Access Compliance Report

Public Rights-of-Way

(Curb Ramps)

Intersection ID: 10040204	Main Street: TYVOLA_RD	Cross Street: N/A	Location: NW
ADA ID: 3A2E3DABE102	Ramp Type: PerpDiag	Initial Pass/Fail: Fail	Overall Compliance: No
			Severity Score: 35

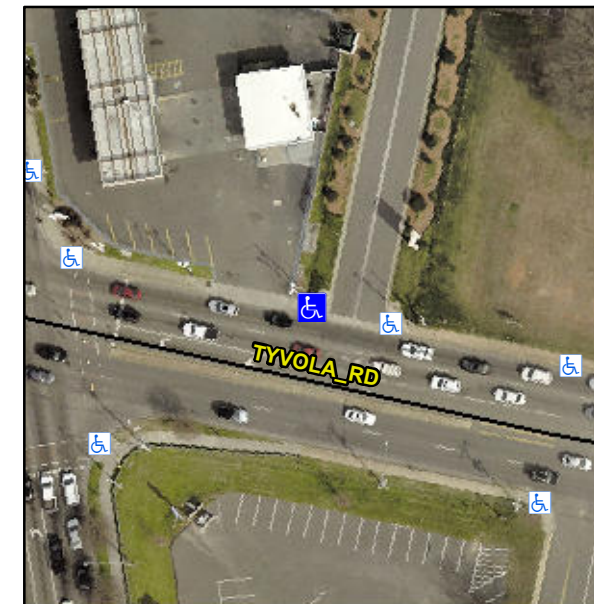
Not Found, R304.5.1, R304.2.2, R304.5.3

Compliance	Description	Data	Compliance	Description	Data
N/A	Ramp Length (in)	63.0	No	Ramp Slope (%)	14.3
No	Ramp Width (in)	45.0	No	Ramp XSlope (%)	2.9
N/A	Flare Type LT	N/A	N/A	Flare Type RT	N/A
N/A	Flare Slope LT (%)	N/A	N/A	Flare Slope RT (%)	N/A
N/A	Flare Traversable LT?	N/A	N/A	Flare Traversable RT?	N/A
N/A	Landing Length (in)	N/A	N/A	DWS Provided?	N/A
N/A	Landing Width (in)	N/A	N/A	DWS Contrast?	N/A
N/A	Landing Slope (%)	N/A	N/A	DWS Length (in)	N/A
N/A	Landing X Slope (%)	N/A	N/A	DWS Full Width?	N/A
N/A	Landing Curb? (Y/N)	N/A	N/A	DWS Offset (in)	N/A
N/A	Shared Landing?	N/A			
N/A	Gutter Ponding?	N/A	N/A	Gutter Slope (%)	N/A
N/A	Gutter Lip Ht (in)	2.0	N/A	Gutter X Slope (%)	N/A
N/A	Painted X Walk1?	No	N/A	Painted X Walk2?	No
	X Walk 1 Direction	To S		X Walk 2 Direction	To S
N/A	X Walk 1 Width (in)	N/A	N/A	X Walk 2 Width (in)	N/A
	X Walk 1 Slope (%)	4.9		X Walk 2 Slope (%)	2.1
	X Walk 1 X Slope (%)	3.7		X Walk 2 X Slope (%)	2.4

Remove & Replace Curb Ramp With Two New Directional Ramps or Equivalent.
